RESEARCH REACTOR CENTER

SUBJECT: Written communication as specified by 10 CFR 50.4(b)(1) regarding responses to the “University of Missouri at Columbia - Request for Additional Information Regarding the Renewal of Facility Operating License No. R-103 for the University of Missouri at Columbia Research Reactor (TAC No. ME1580),” dated April 17, 2015

Attached are responses to the April 17, 2015, request for additional information, which were in the form of ten (10) questions.

Figure 1 – Detailed MCNP model of the Lower “Z” Storage Basket Configuration

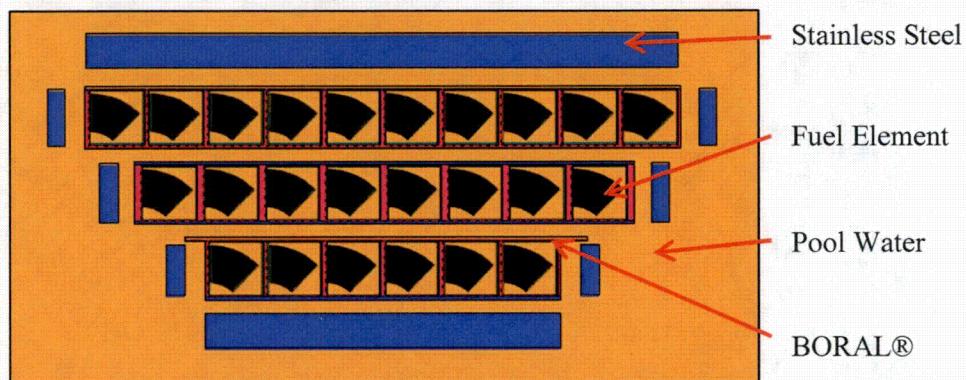
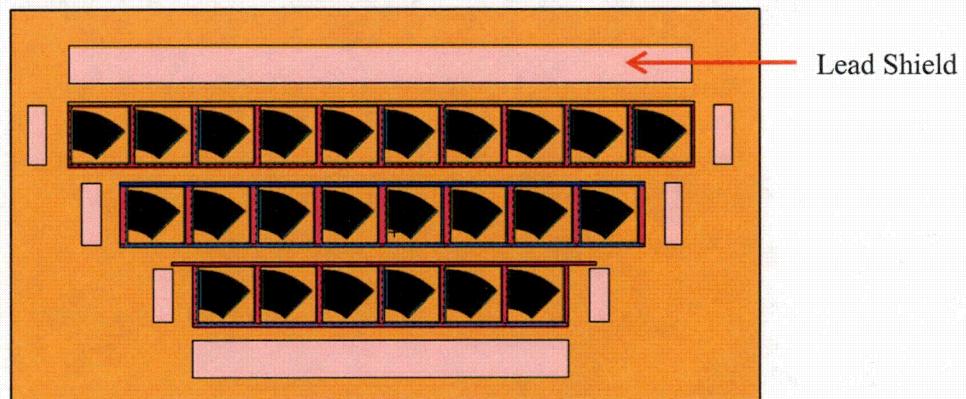
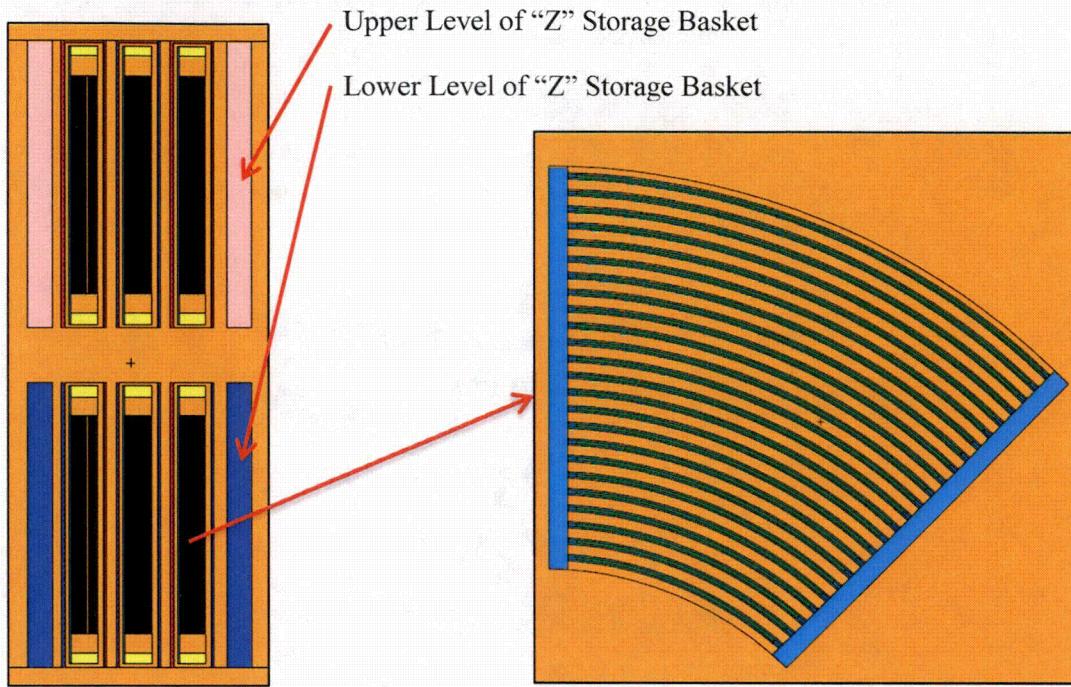
2. *NUREG-1537, Section 9.2, "Handling and Storage of Reactor Fuel", provides guidance that the licensee provide analyses and methods to demonstrate the secure storage of new and irradiated fuel with a criticality limit of $k_{eff} < 0.90$. The NRC staff's review of the MURR SAR and Hazards Summary Report could not find a criticality analysis supporting the use of any fuel storage locations outside of the core. Identify the locations that may be used for the storage of new or irradiated fuel, and provide supporting criticality analyses, or justify why no additional information is needed.*

Because the criticality analyses for the “Z” storage basket are somewhat dated and vaguely documented, MURR performed an updated criticality analysis of the upper and lower levels of the “Z” storage basket using the general-purpose Monte Carlo N-Particle (MCNP) code. The following describes the methodology and results.

The “Z” storage basket stores fuel elements that have burnups of 0 to 150 MWds. The baskets are lined with 26- to 29-inch tall sheets of 0.25- to 0.3125-inch thick B₄C (BORAL®) as the absorbing material to prevent the stored fuel configuration from reaching criticality. Figure 1 shows the layout (i.e. a detailed MCNP model) of the lower “Z” storage basket configuration.

The upper ‘Z’ storage basket configuration layout shown in Figure 2 is very similar to the lower basket with the exception of lead shields surrounding the basket instead of stainless steel, as in the lower basket.

The active region of the fuel elements in the lower and upper baskets is separated in height by approximately seven (7) inches. Each fuel element in every storage location is modeled in full detail, with all 24 aluminum clad UAl_x fuel plates. Figure 3 shows very detailed MCNP modeling of an individual MURR fuel element and the elements in their lower and upper “Z” storage basket configurations.

Criticality (i.e. KCODE) calculations using MCNP version 5 with the ENDF/B-VII.0 data libraries were performed for two detailed instances of the “Z” storage basket configuration: (1) a single basket (lower), and (2) both lower and upper baskets together. All calculations were performed for 20 million source particles. For the two instances, the basket(s) were filled to their maximum capacities (24 fuel elements) with fresh, highly-enriched uranium (HEU) UAl_x MURR fuel elements. These configurations describe the most conservative, worst-case conditions for the “Z” storage baskets. Table 1 provides the computed K_{eff} using the MCNP models of the two configurations of the “Z” storage basket.

Figure 1 – Linkage of the Codes Used in the Analysis Suite

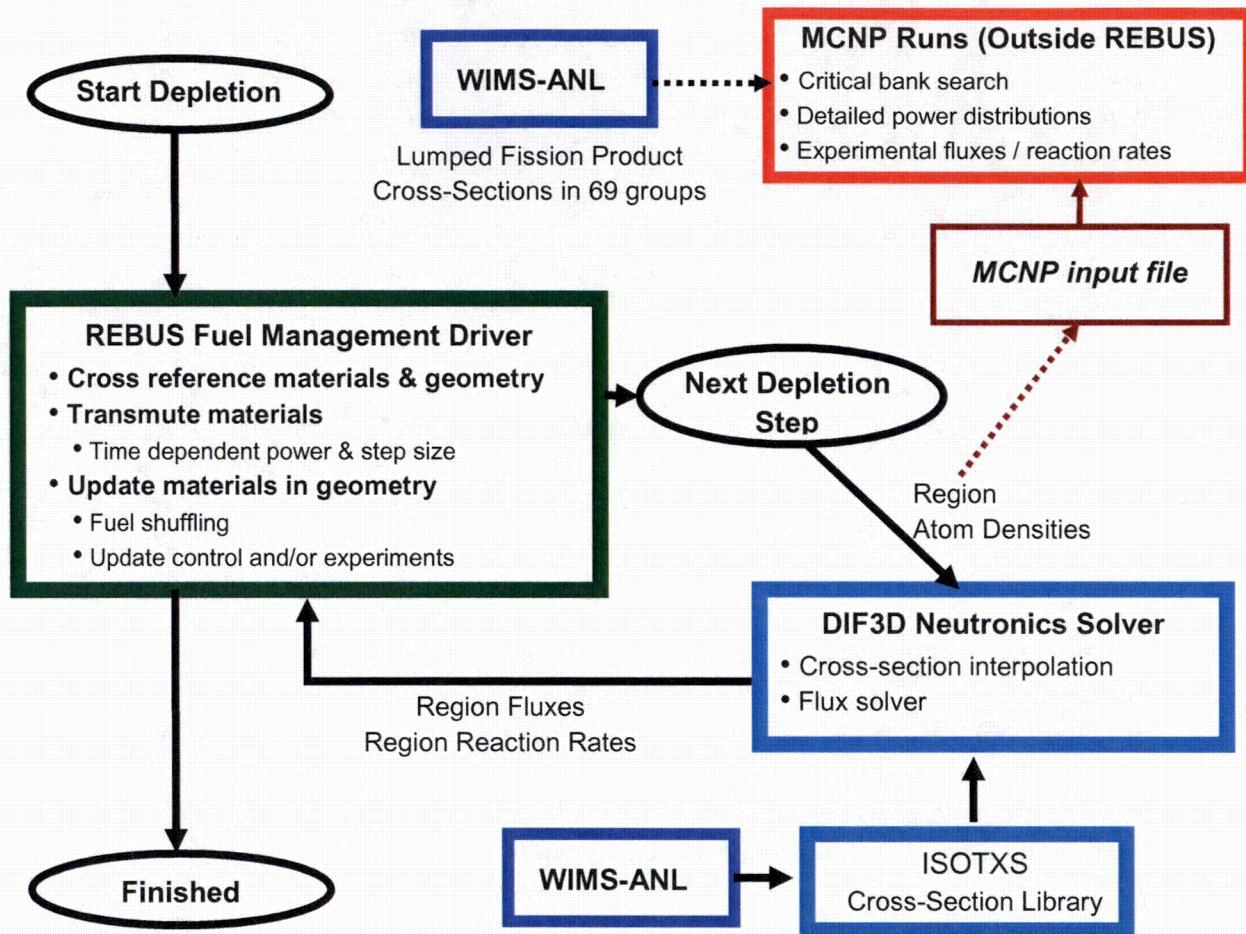
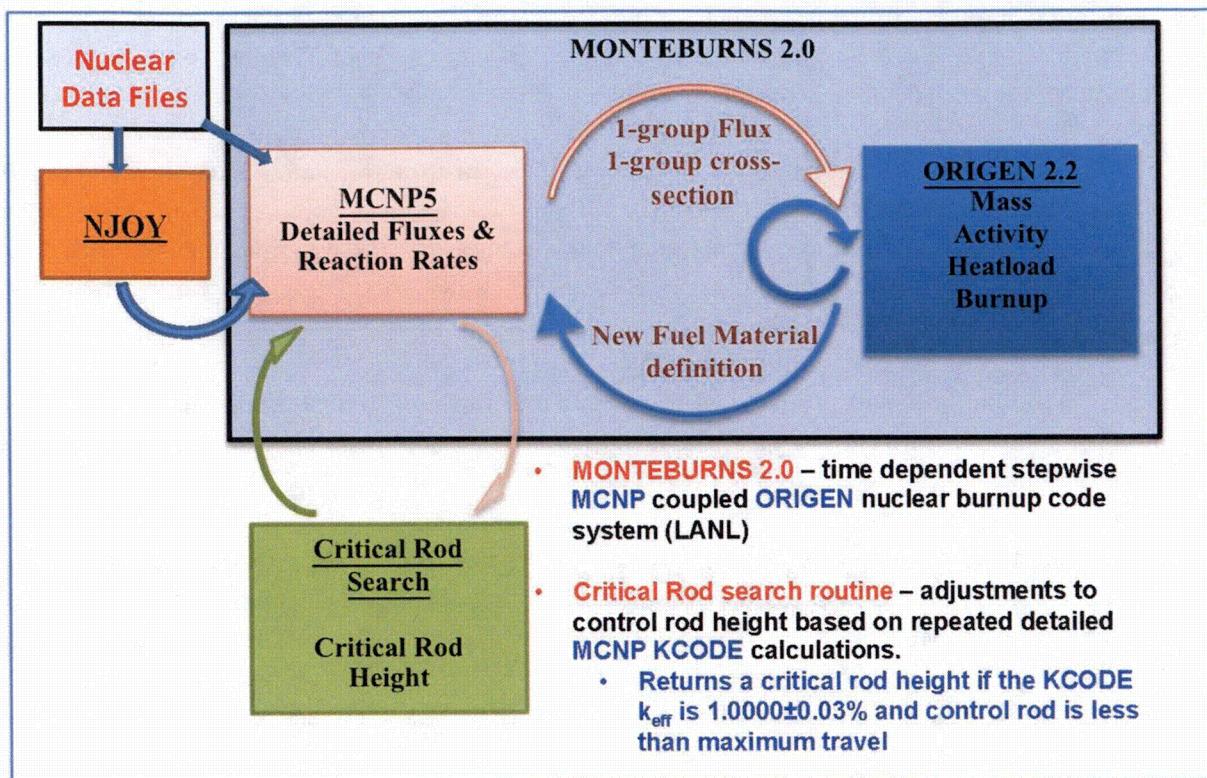
3. *NUREG-1537, Section 4.5.1, "Normal Operating Conditions," and Section 4.5.2, "Reactor Core Physics Parameters," provide guidance that the licensee should identify their analytical methods, including calculations of individual control blade worths, core excess reactivity, and coefficients of reactivity, and compare the results with experimental measurements. The MURR SAR, Section 4.5 states that analyses have been performed using PDQ, EXTERMINATOR, and BOLD-VENTURE codes using R0, RZ, and R0Z models. The NRC staff noted other analyses (e.g., the RAI responses supporting the NRC staff review of License Amendment No. 36, ADAMS Accession Nos. ML11237A088 and ML12150A052) used Estimated Critical Position (ECP) comparisons with the Monte Carlo Neutron Production code. The design code used to support the T&H analysis appears to be DIF3D. The NRC staff is not clear as to which analytical method is the final supporting analysis to be reviewed for the MURR license renewal application. The final supporting analysis should be the source for information used in accident and event analysis (e.g., peaking factors, control blade worths). Furthermore, in response to RAI 4-14.c., (ADAMS Accession No. ML103060021), it is not clear how the stuck control blade was determined, what the relative reactivity worth is for the other control blades in the shutdown margin (SDM) analysis, and whether they are calculated, measured, or compared. The following information is needed:*

As part of the on-going collaboration, which started in 2006, between MURR staff and Argonne National Laboratory (ANL) analysts for the purpose of determining the feasibility of converting MURR from HEU to low-enriched uranium (LEU) fuel, ANL has assembled a neutronics analysis code suite utilizing WIMS-ANL, REBUS-DIF3D and REBUS-MCNP. Figure 1 below illustrates the linkage of the codes in the analysis suite.

The flow diagram for the suite of codes implemented at the MURR for routine core-physics analysis is shown in Figure 2.

Figure 3 – Calculated Differential Worth Curves for All-Fresh Shim Control Blades in an All-Fresh Fuel Core Configuration

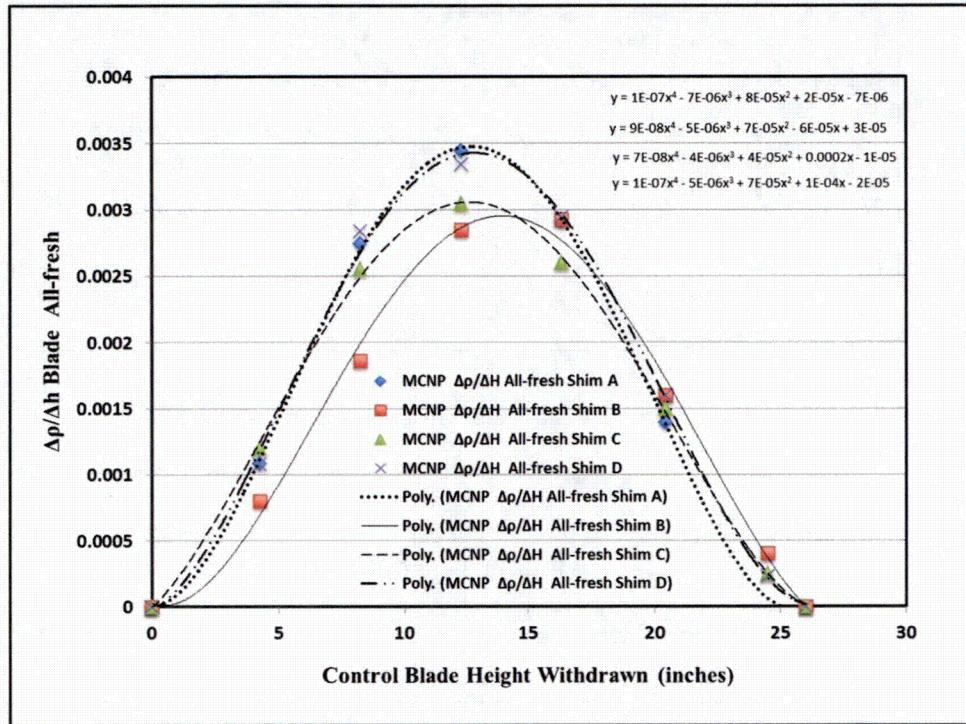
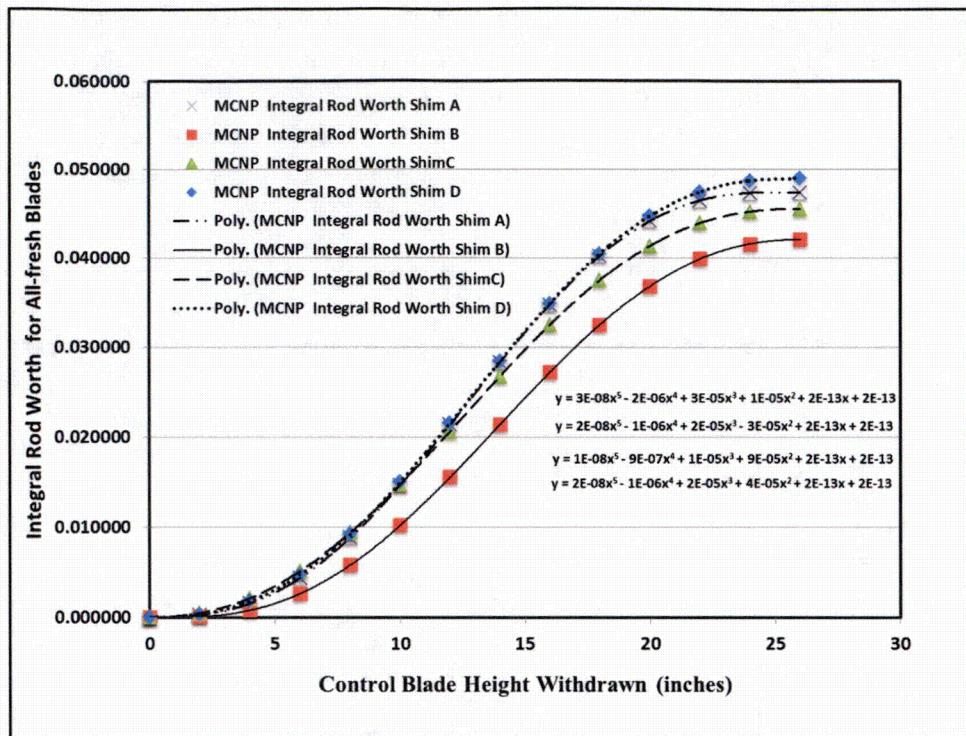
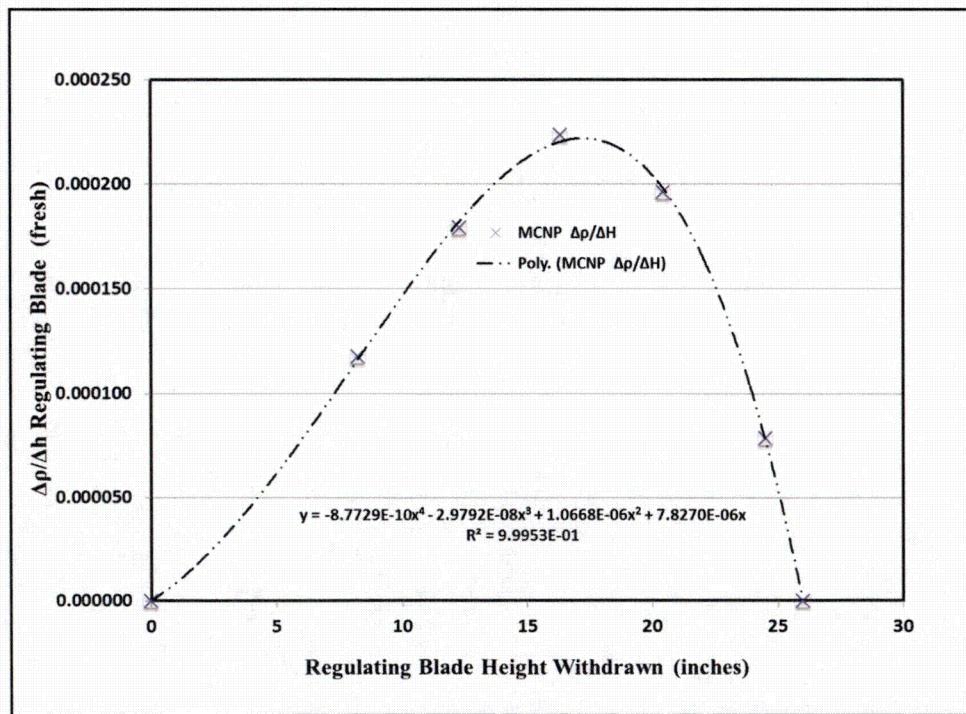
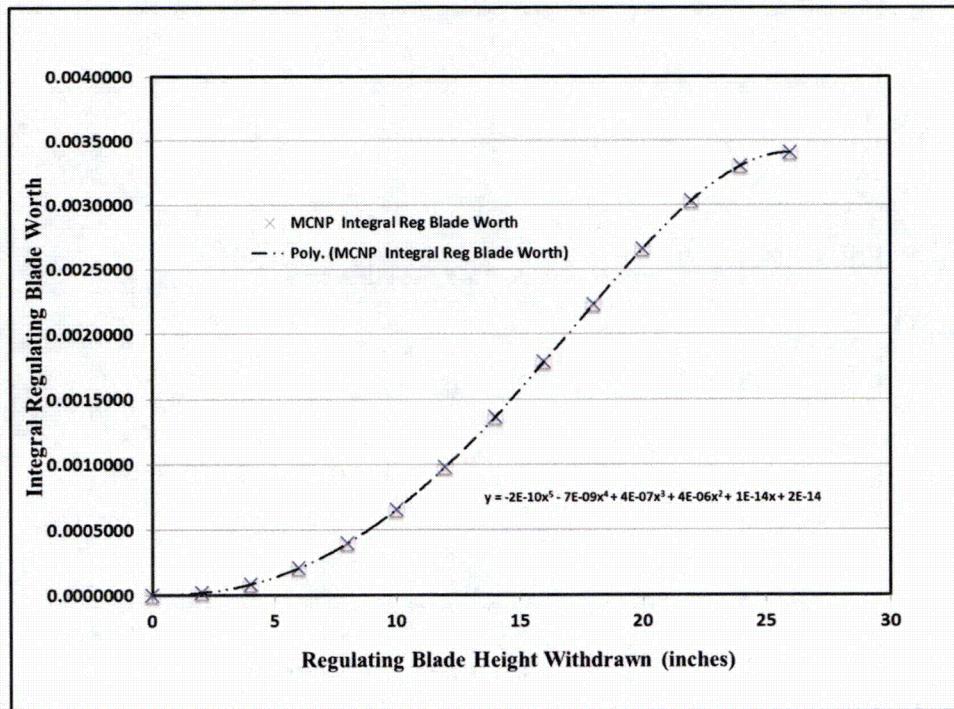
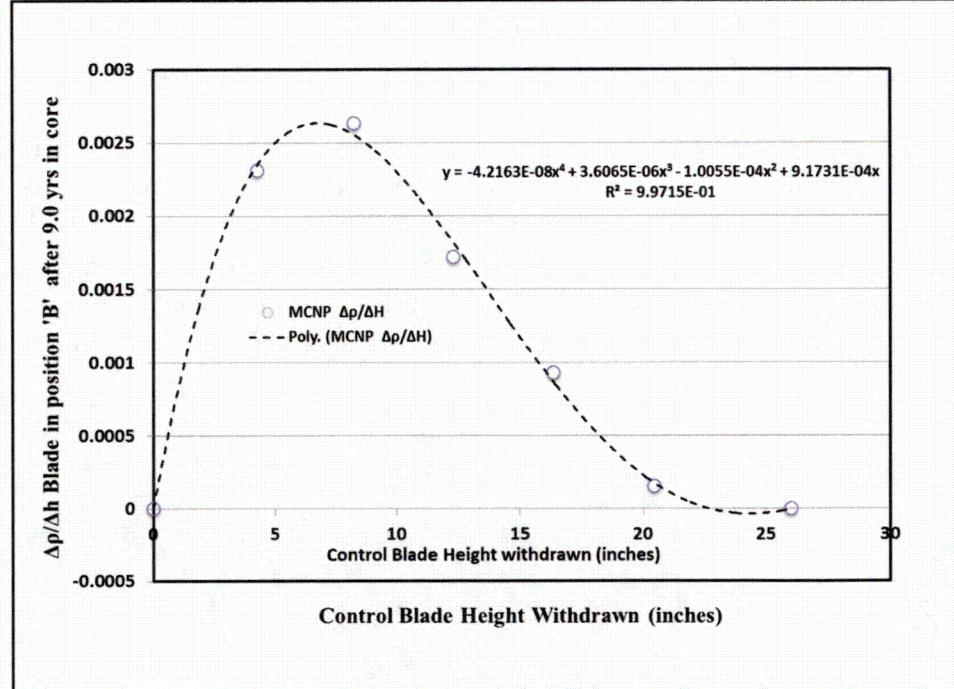
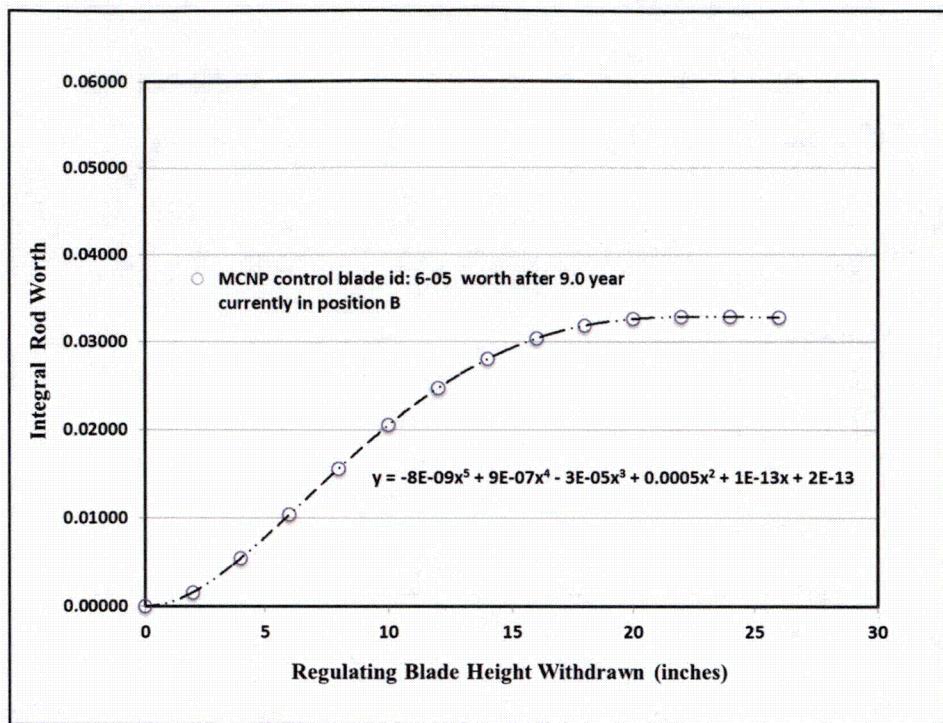
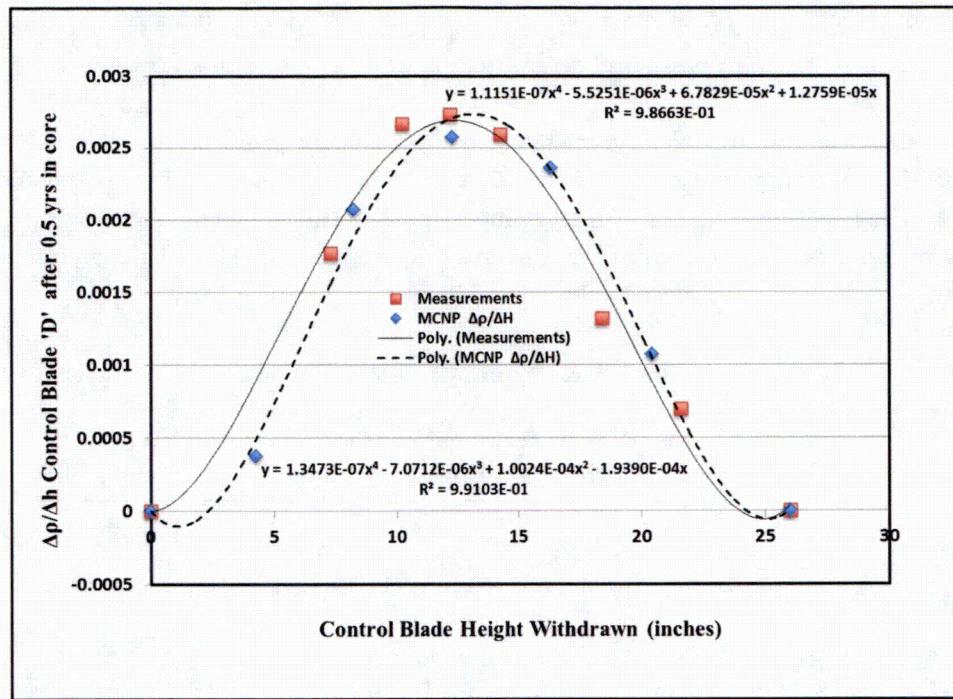
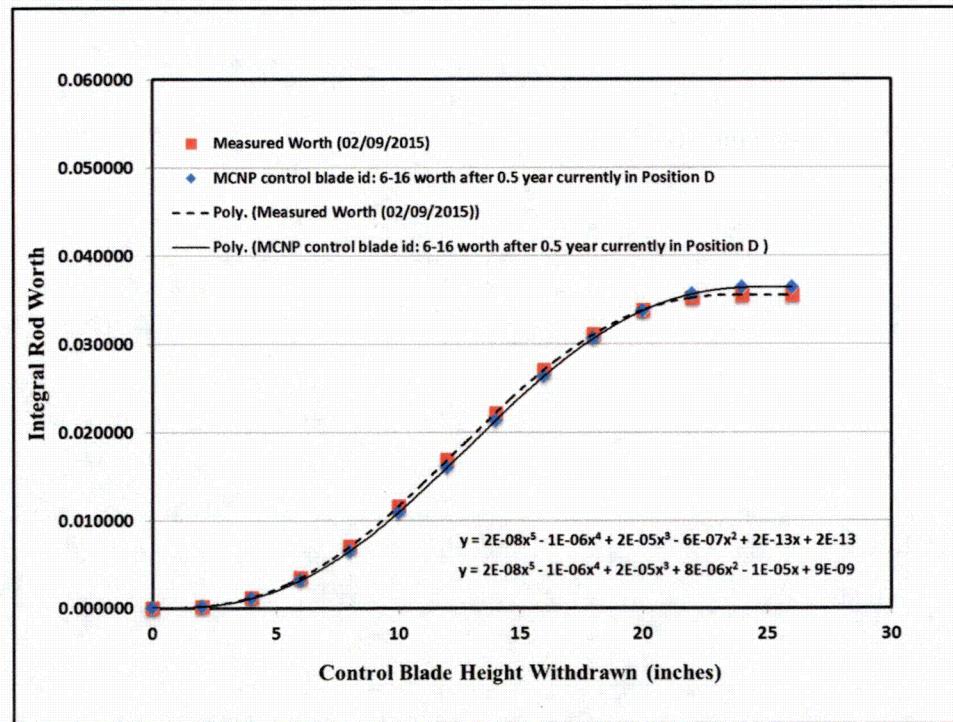
- c. *Provide calculated and measured control blade worths (Shim-1, Shim-2, Shim-3, Shim-4, and Regulating blades) for a given core configuration at a low power, no xenon condition, or justify why this information is not needed.*

Using the detailed MCNP core model of MURR, the differential and integral worth of the four shim control blades, and that of the stainless steel regulating blade, were calculated and the results are shown in Figures 3 through 6. The calculations were performed for fresh (non-depleted) control blades using a fresh core with no xenon. In order to show the effect of control blade depletion with operational history, the differential and integral worth curves of a single blade with a core residence time of over 9 years are also shown in Figures 7 and 8, respectively.

Shim control blades ‘B’ and ‘C’ are worth slightly less than control blades ‘A’ and ‘D’ since blades ‘B’ and ‘C’ are located near two highly “black” fast flux irradiation reflector elements situated on the west side of the core, adjacent to these control blades.

As mentioned before, every time a control blade is changed out after a bi-annual inspection, the reactivity worth of the newly installed control blade is measured and the total bank worth curve (combined worth of all four shim control blades) is recalculated for the purpose of reactor physics calculations (such as ECP predictions, reactor core shutdown margin, estimation of unknown sample reactivity worths, etc.). To serve as a benchmark for the calculated control blade worths, a single blade was selected. Using a detailed mixed-core, mixed-burnup control blade model of the reactor configuration during the last Shim-4 (control blade ‘D’) inspection and replacement the blade worth ‘D’ measurements were simulated. The measured control blade worth curves for blade ‘D’ are compared against the blade worth curves calculated by the MCNP model. The results are shown in Figures 9 and 10.
